Re: Interrogatory Responses of Canadian Niagara Power Inc. (EB-2009-0283)

Responses to the Interrogatories of Board Staff

**Figure 3. CNP Fort Erie Tie MW vs. PS46 Angle**

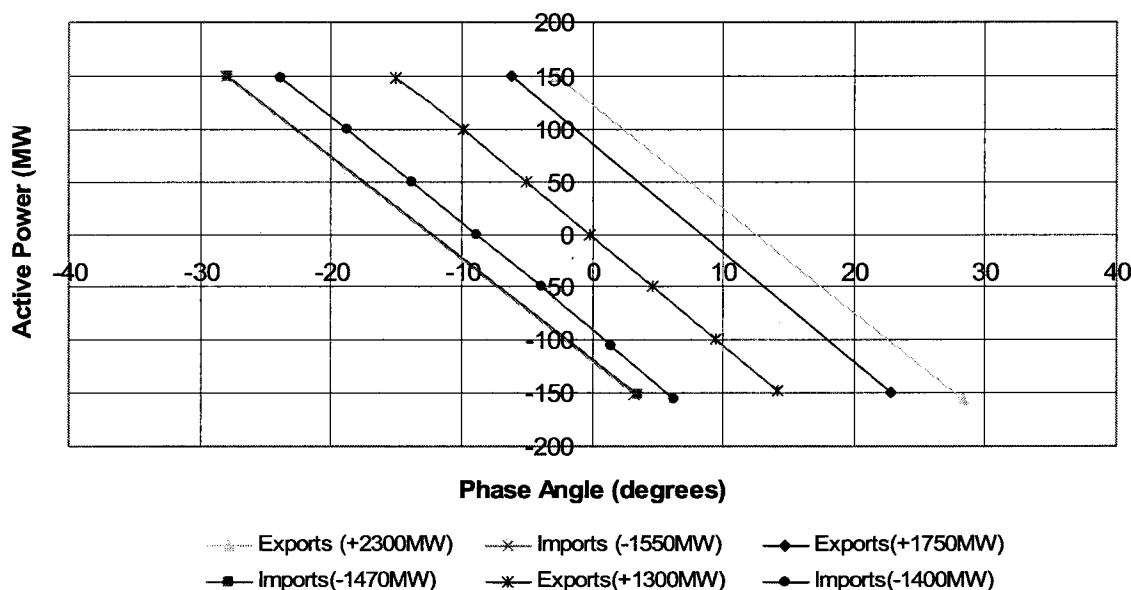
In order to determine the angle shift requirement for PS46, the flow on the new tie line was varied between ± 150 MW for all cases previously described. The study results are illustrated in Figure 3.

The results indicate that an operating capability of ± 40 degrees for PS46 can control the active power flow on the new tie from import 150 MW to export 150 MW. This angle range proved to be feasible for the assessed conditions. Figure 3.0 also illustrates that a 1° change in phase angle results in a 10 MW change on this new tie.

Phase Shifting Transformer must be able to provide an operating range of ± 40 degrees. The phase shifter must push power out of the Area when it is tapped down (i.e. moving from tap 2 to tap 1 pushes power out of Ontario). Operation of PS46 must be directed by the IESO only therefore tap changes are not permissible unless directed by the IESO.
